February 22, 2022

Re: Lot 39 5004 Sandpiper Ct. Lot Specific Grading and Drainage Plan

Yolanda Padilla Moyer, P.E.
Vice President
Community Development and Planning

SHEET
C 2

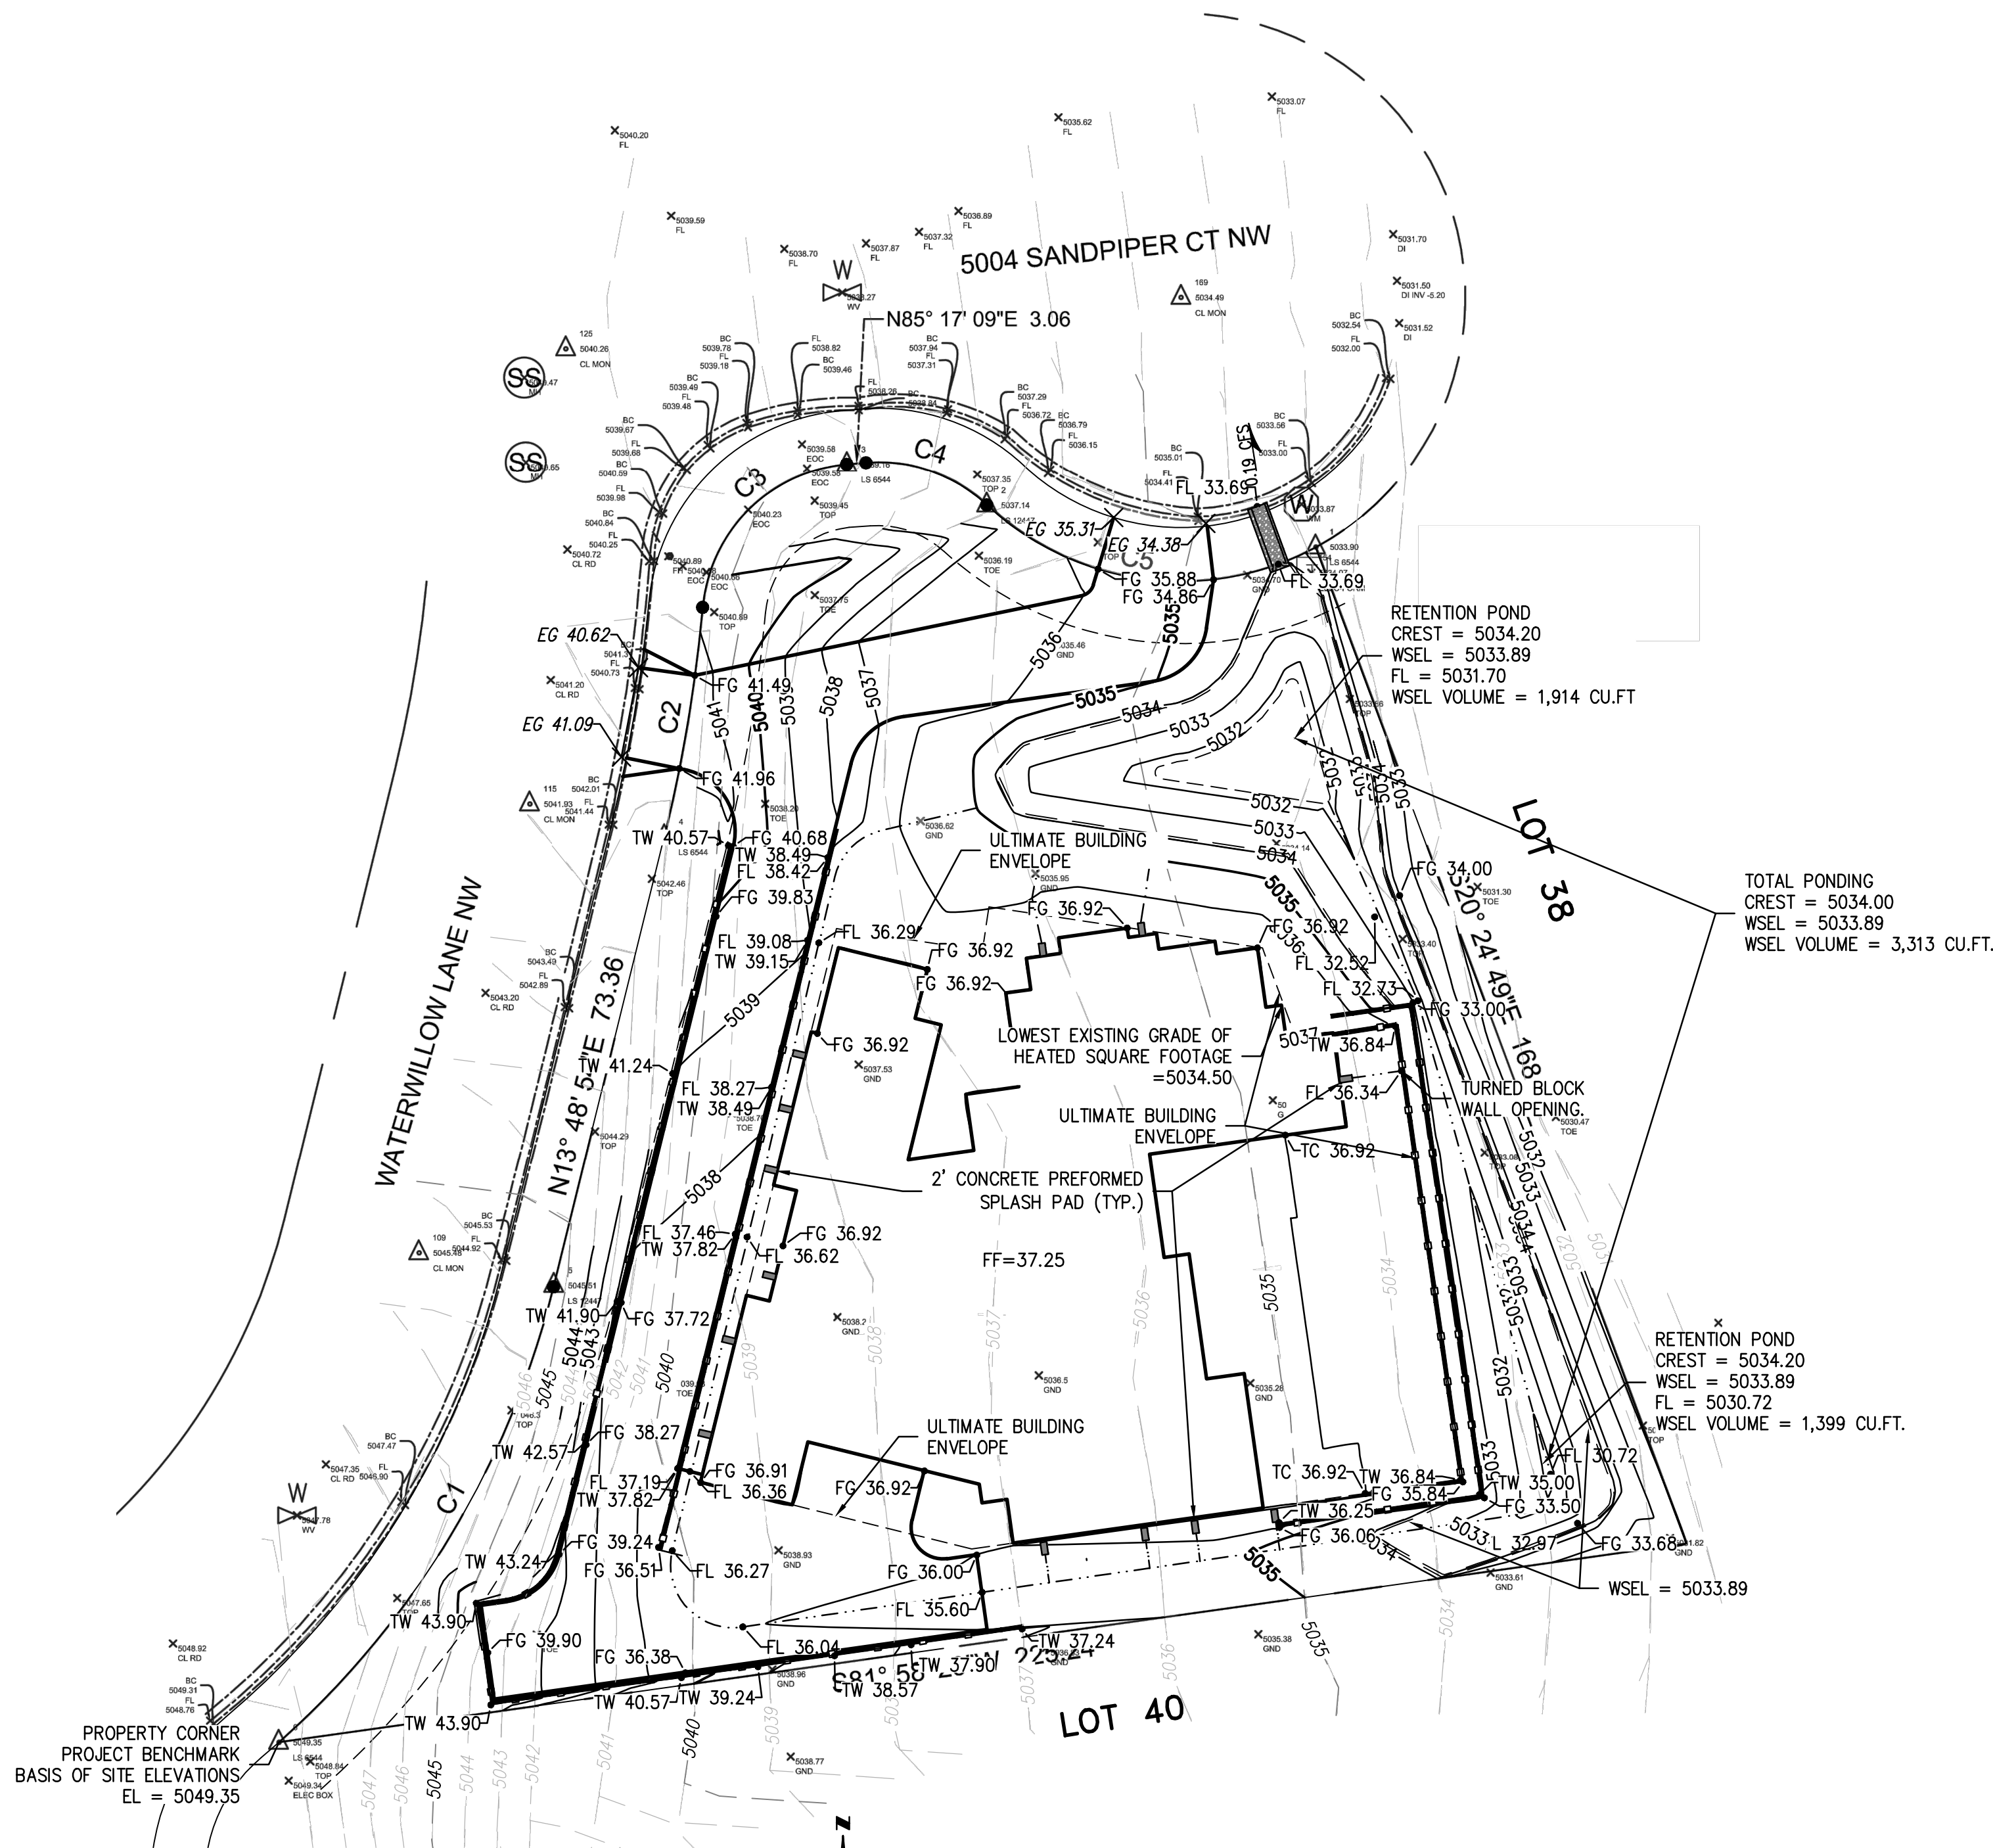
Based on the revised grading and drainage plan for the above referenced Lot stamped dated 02/22/2022 by Ron E Hensley, The Groupe, it appears that all the comments have been addressed in regard to the grading and drainage. The plan is attached for reference.
